# Product modification

046-0041-01

## 11802 ENHANCEMENT

This kit contains parts and instructions that adds firmware version 9.0 to the 11802 Sampling Oscilloscope. This kit also removes and replaces the Acquisition Unit and Time Base/Controller circuit board A5.

Figure 6, - Time Base/Controller ckt bd A5.

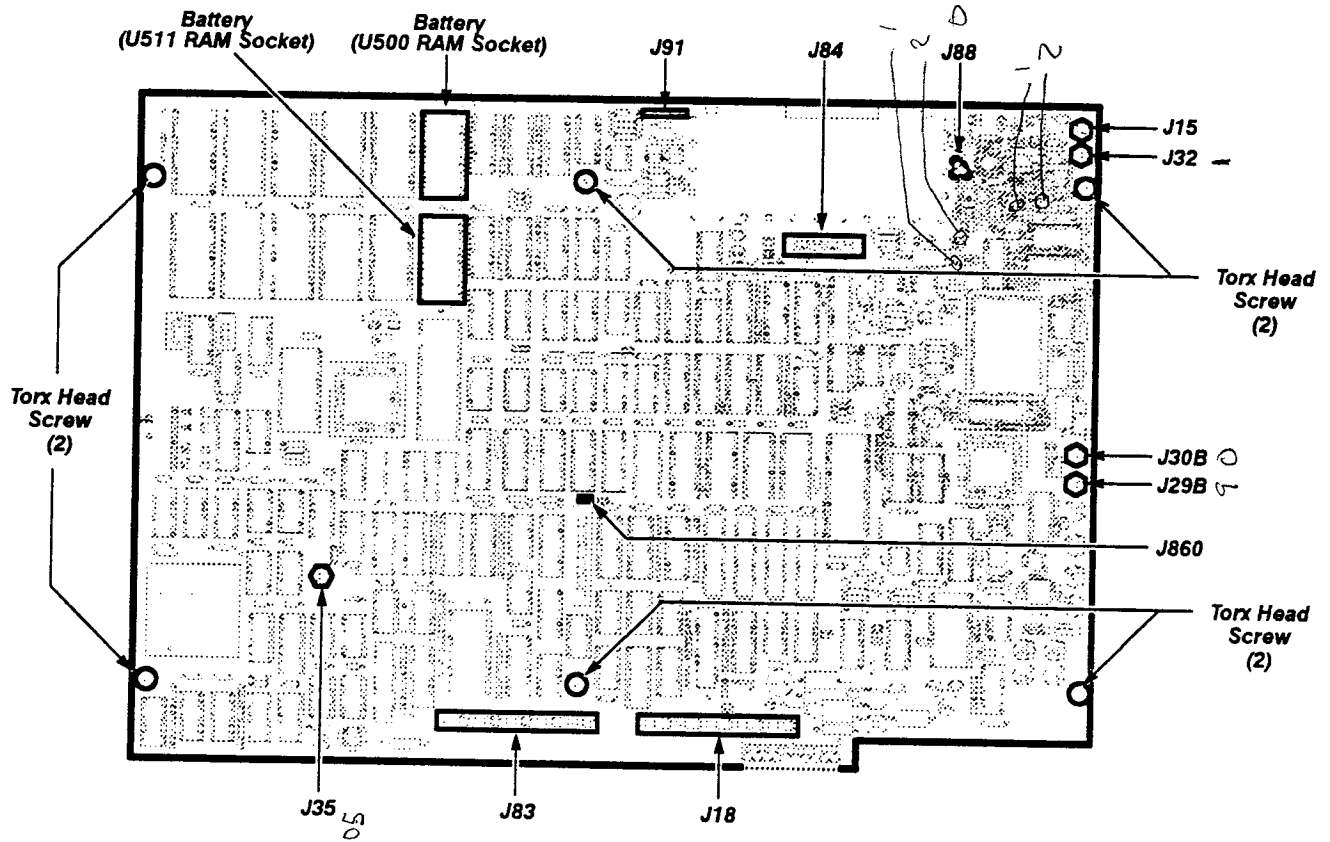
- 1. Disconnect the coaxial cables J15, J29B, J30B, J32, J35, and J88 located on the Time Base/Controller circuit board A5.
- 2. Disconnect the ribbon cables J18, J83, J84, and J91 located on the Time Base/Controller circuit board A5.
- 3. Disconnect the coaxial cables J16 and J87 located on the Trigger Select circuit board A24.
- 4. Remove the six (6) Torx drive screws that secure the Time Base/Controller circuit board A5. Then remove the circuit board from the instrument.

- 5. Install U300, U310, U400 and U410 microcircuits in the Time Base/Controller circuit board A7.
- 6. Replace the Time Base/Controller circuit board A5 using the hardware removed in steps 4 in this section.
- 7. Replace the Trigger Select circuit board A32 securing it using the Torx drive screws removed in step 8, in the previous section.
- 8. Reconnect J86 and J89 coaxial cables to the Trigger Select circuit board removed in step 9. **CHECK cables to ensure connections are as follows: Delay line 1 is connected to J89, and Delay line 2 is connected to J86.**

Figure 7, - EPROM locations.

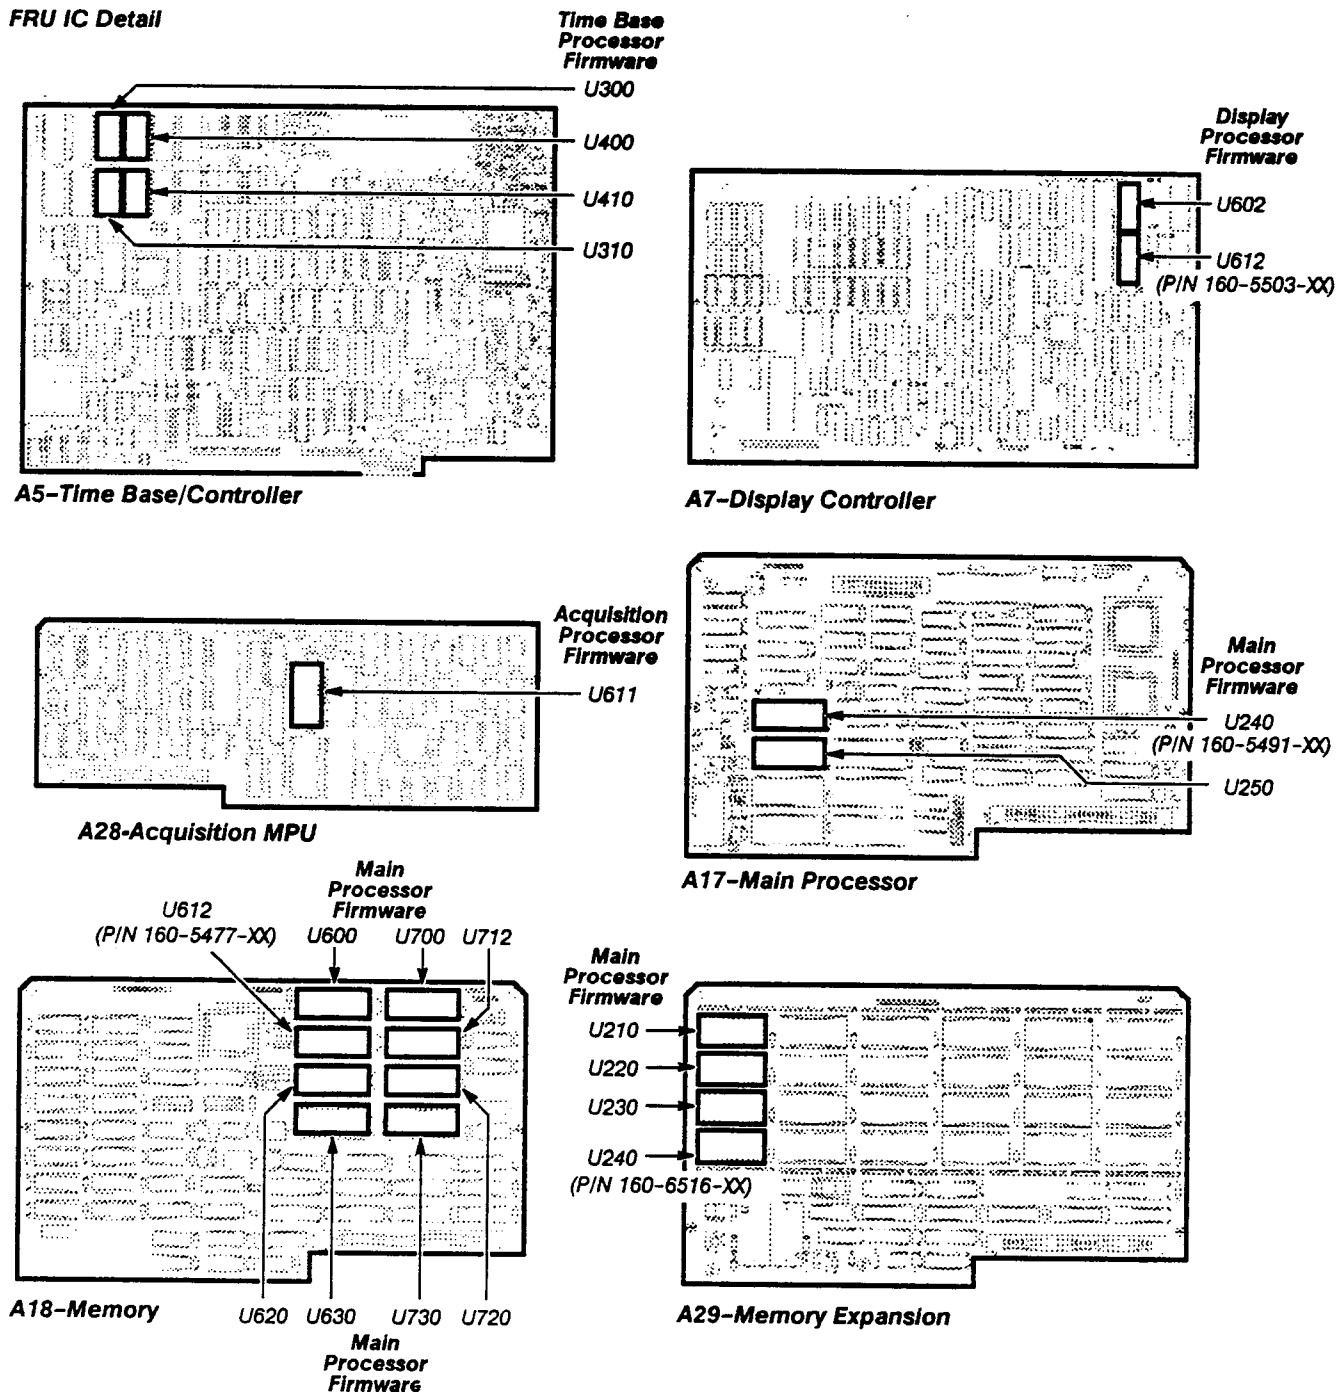
- 3. Remove the Memory circuit board A18 from the card cage.
- 4. Replace the following microcircuits on the Memory circuit board A18 with the new microcircuits provided in this kit:

U600	160-5479-XX
U612	160-5477-XX
U620	160-5475-XX
U630	160-5473-XX
U700	160-5619-XX
U712	160-5478-XX
U720	160-5476-XX
U730	160-5474-XX

- 5. Replace the Memory circuit board A18 to its former location in the card cage.
- 6. Remove the Memory Expansion circuit board A29 from the card cage. The Memory Expansion circuit board is located next to the Memory circuit board A18.
- 7. Replace U210 and U220, microcircuits with the new microcircuits provided in this kit. Then install U230 and U240 microcircuits provided in this kit.
- 8. Replace the Memory Expansion circuit board A29 to its former location in the card cage.
